SERVICE BULLETIN

Classification: FA15-003b	Reference: NTB15-062b	Date: October 26, 2016
------------------------------	--------------------------	---------------------------

2014-2016 ROGUE; POPPING NOISE FROM FRONT SUSPENSION WHEN TURNING

APPLIED VEHICLE: 2014-2016 Rogue (T32)

Figure 1

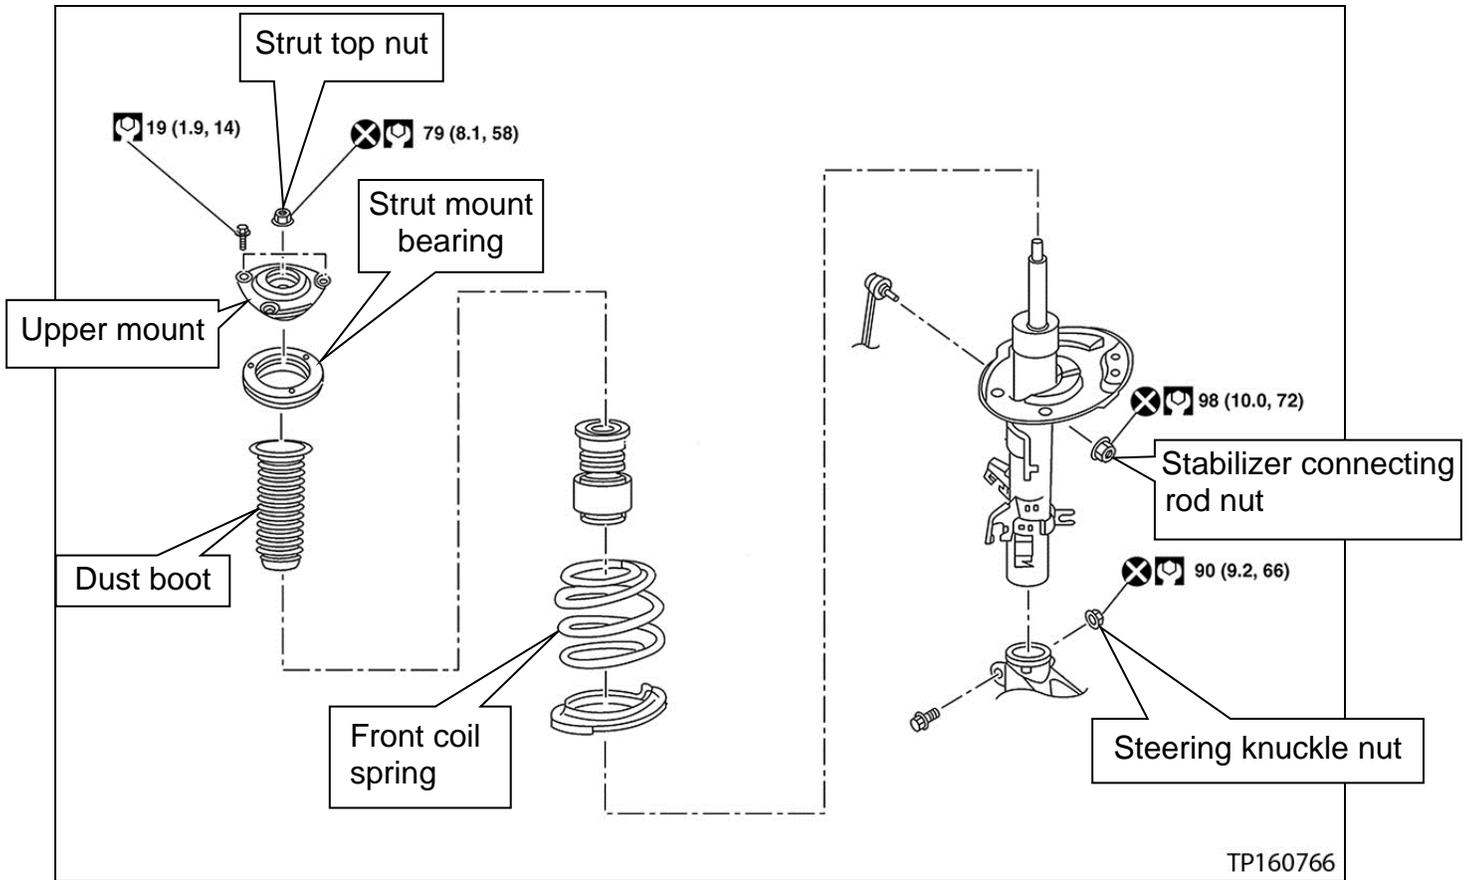
Parts to be replaced on both front strut assemblies are called out in Figure 1 below.

Figure 4

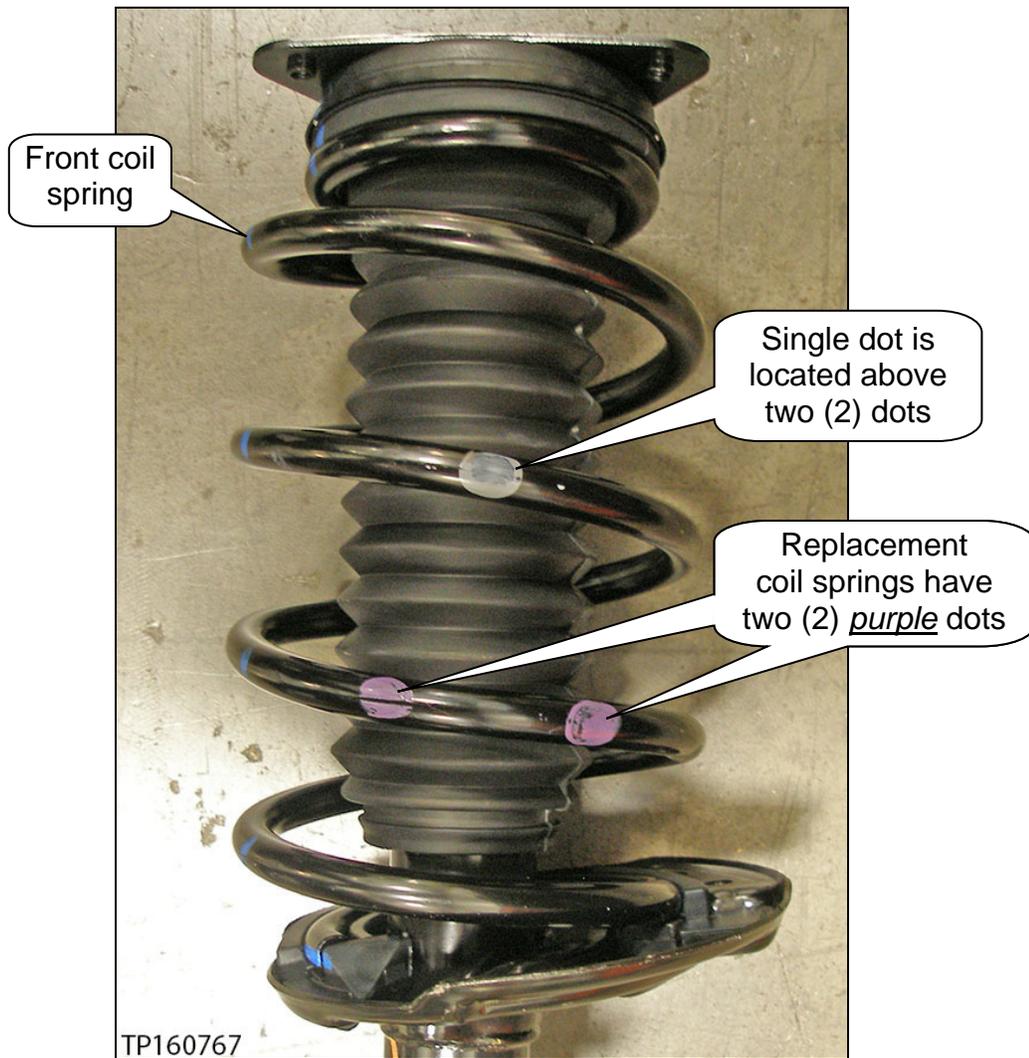
- With the coil spring installed, the single dot must be ABOVE the two dots (see Figure 4).

Figure 7

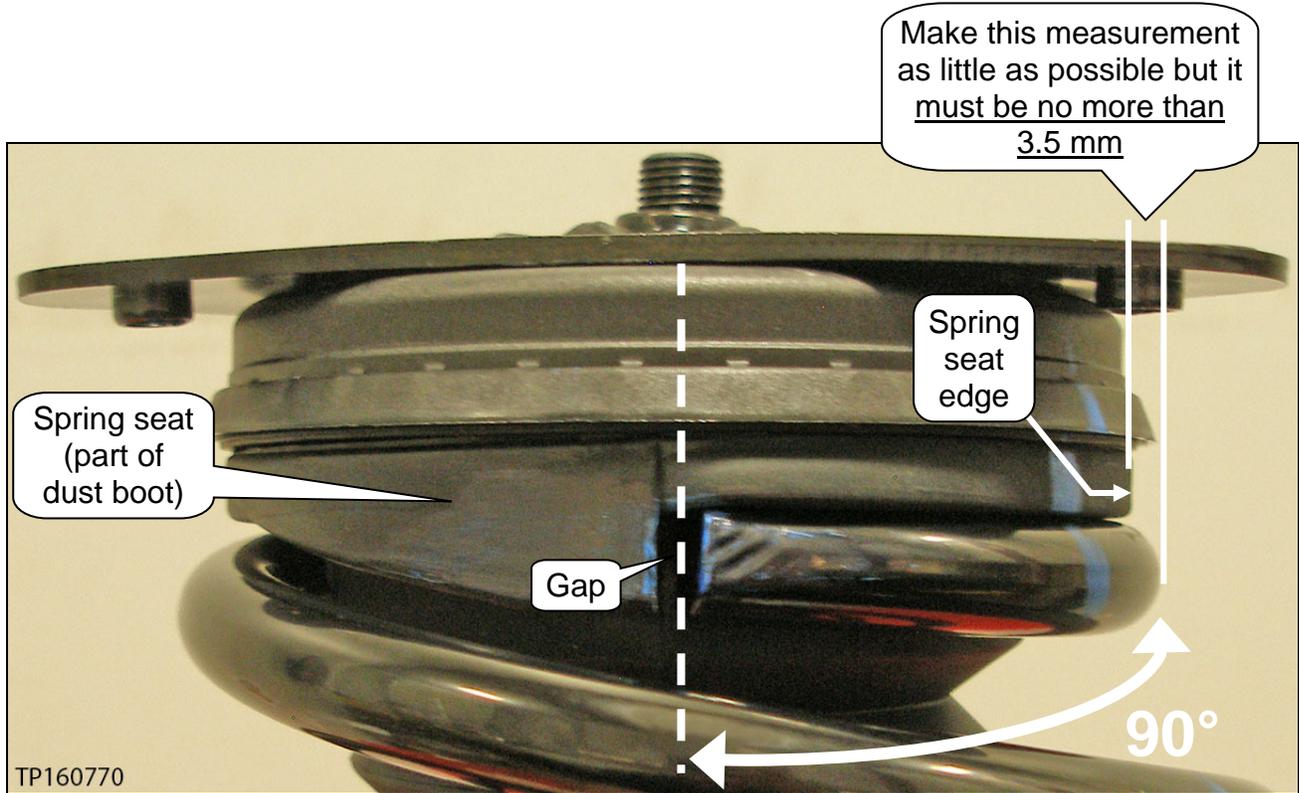
- The side edge of the upper coil spring, located 90° counter clockwise from the gap, needs to be as little as possible but it must be no more than 3.5 mm from the edge of the spring seat (see Figure 7).
- If the measurement is greater than 3.5 mm, rotate the coil spring into the spring seat (close the gap).
